1997 - 1999: Service Bulletin: Engine Low Coolant Light Comes On (Inspect Rad. Surge Tank, Replace/Reposition)

Subject: Engine Low Coolant Light Comes On At Start-Up (Inspect for 2nd Design Radiator Surge Tank and Replace/Reposition)

Number: 99-06-02-016

Models: 1997-1999 Chevrolet Corvette (1997 Models Built Prior to VIN Breakpoint V5104277)

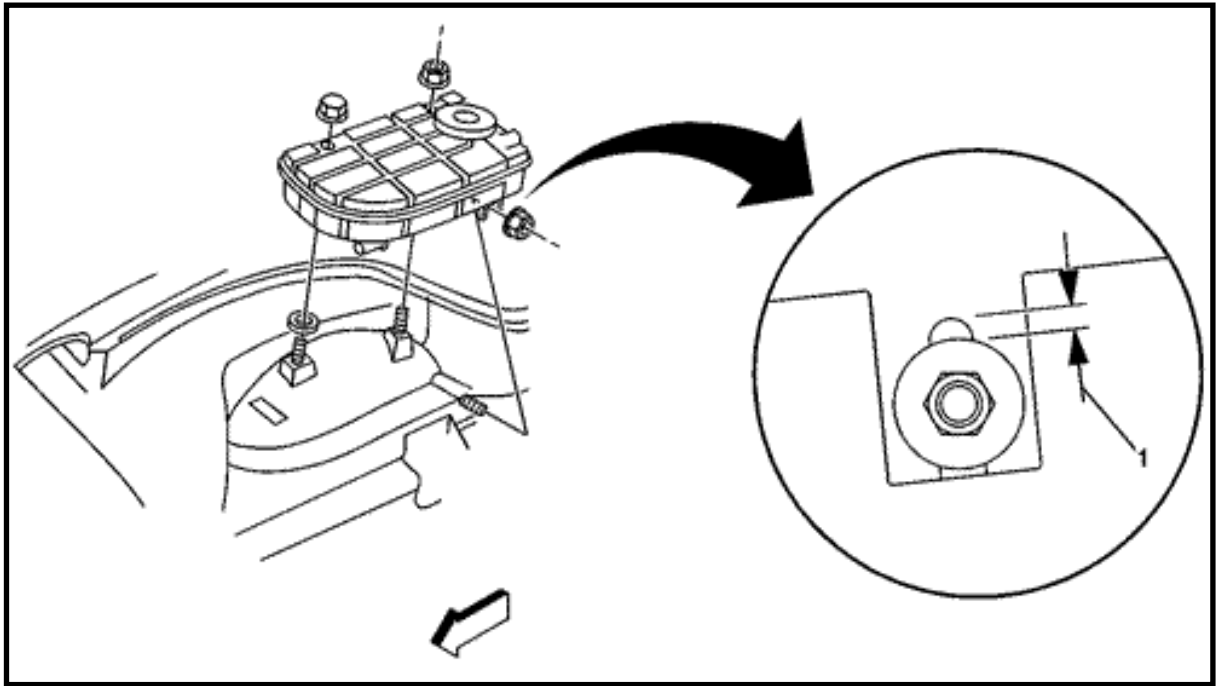
Cause: This condition may be caused due to the low coolant sensor being mounted in the rear of the radiator surge tank. When the vehicle is parked with the front lower than the rear, the coolant settles in the front half of the surge tank and with the switch in the rear of the tank, the switch float may be low enough to trigger the light. The "low coolant" light may come on if:

- The vehicle is a 1997 model, built before VIN V5104277, with the old design radiator surge tank.
- The radiator surge tank is improperly installed in the vehicle.
- The coolant level in the vehicle coolant system is low.
- The float in the tank is sticking.
- The coolant level switch connector is improperly connected.

1. For 1997 vehicles built prior to VIN breakpoint V5104277, replace the radiator surge tank and inspect for an out of position wiring harness under the tank. To repair the harness, position the harness downward and secure with a tie strap. To determine if the surge tank is of the first or second design, inspect the low coolant switch cavity in the surge tank. If the surge tank cavity extends 16 mm (5/8 in) below the bottom of the surge tank, the tank is of a second design tank. If the cavity is less than 15 mm (19/32 in) replace the tank with P/N 10405218.

2. For all vehicles, check the level of the tank by viewing the lower mount on the tank. Less than 2 mm (.08 in) (#1) of the mounting slot should be visible above the attaching nut. If the gap is greater than 2 mm (0.08 in), loosen the surge tank and hold in a downward position to achieve less than a 2 mm (0.08 in) gap above the attaching nut. Tighten the bottom nut first, then both top nuts. **Tighten**

Tighten the nuts to 10N·m (89 lb in).

3. Verify coolant level in surge tank:
 - If engine coolant is hot, above 83° C (180° F), fill the coolant surge tank 12 mm (1/2 in) above the cold indicator mark.
 - If the engine coolant is at ambient room temperature, fill to the top of the cold indicator mark.
